# ITI Comments

## ENERGY STAR-Qualified External Power Supplies

### First Draft: Revised Tier 2 Specification

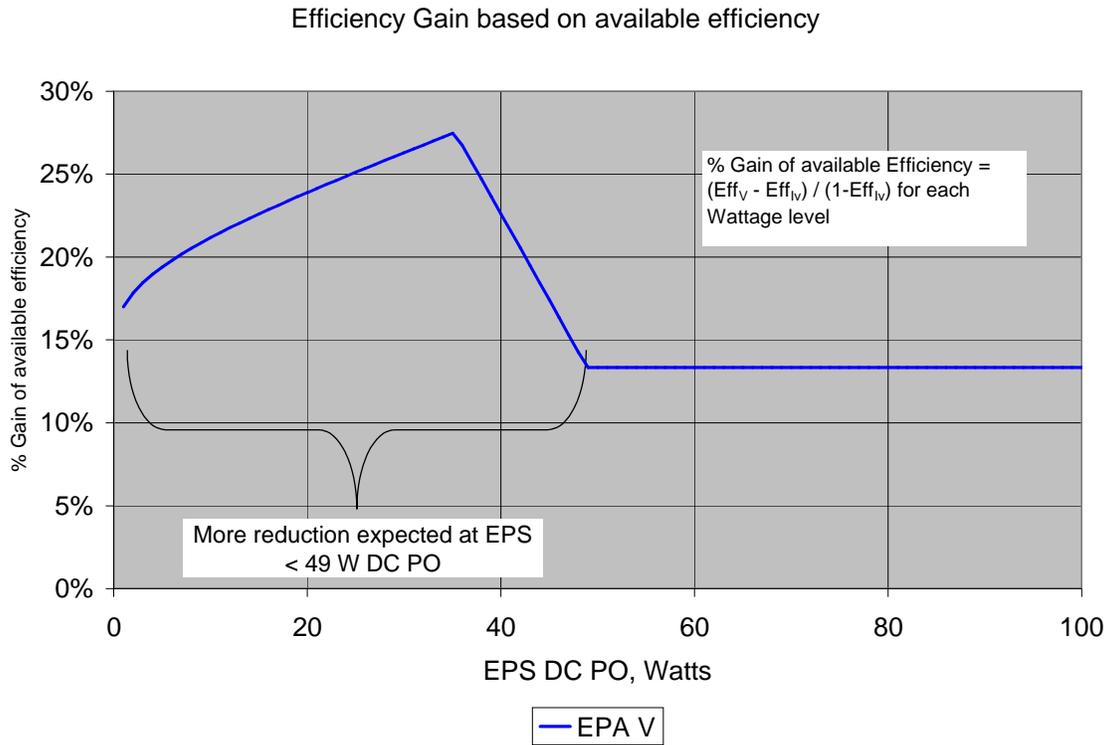
2. The passing rate of 230V EPS is 1/2 to 1/3 of the passing rate of the 115V EPS of the same Wattage range
  - a. Since 230V and 115V EPS do not operate in the same markets, this would create a very low ENERGY STAR presence in the 230V markets. We think this passing rate is too low to adequately encourage a market transformation to the new specification in 230V. With 45% of units being 230V EPS, a poor market transformation would have a significant negative impact on the ENERGY STAR programs in Europe and Asia.
  - b. In addition, for those units which are universal EPS (accepting 100-230V input voltage), the new limits are likely to create a scenario where EPS that pass at 115V will fail at 230V. This is due to the fact that typically universal powers supplies are more energy efficient in both no-load and active efficiency when at 115V versus 230V.

<b>ENERGY STAR proposal</b>									
	<b>Total</b>			<b>115 V</b>			<b>230 V</b>		
<b>DC Power Out</b>	<b>Samples</b>	<b>Passing</b>	<b>%</b>	<b>Samples</b>	<b>Passing</b>	<b>%</b>	<b>Samples</b>	<b>Passing</b>	<b>%</b>
1 to 4.9 W	440	96	22%	225	76	34%	215	20	9%
5 to 9.9 W	526	167	32%	417	151	36%	109	16	15%
10-19.9 W	244	63	26%	97	38	39%	147	25	17%
20 to 49.9 W	166	14	8%	67	9	13%	99	5	5%
50 to 99.9 W	267	72	27%	113	48	42%	154	24	16%
100+ W	121	3	2%	59	1	2%	62	2	3%
Total	1764	415	24%	978	323	33%	786	92	12%

**PROPOSAL:** Set the criteria based on the 230V data. The 115V markets will still received the same efficiency gains through universal power supplies and there will actually be some 230V models for the European Market
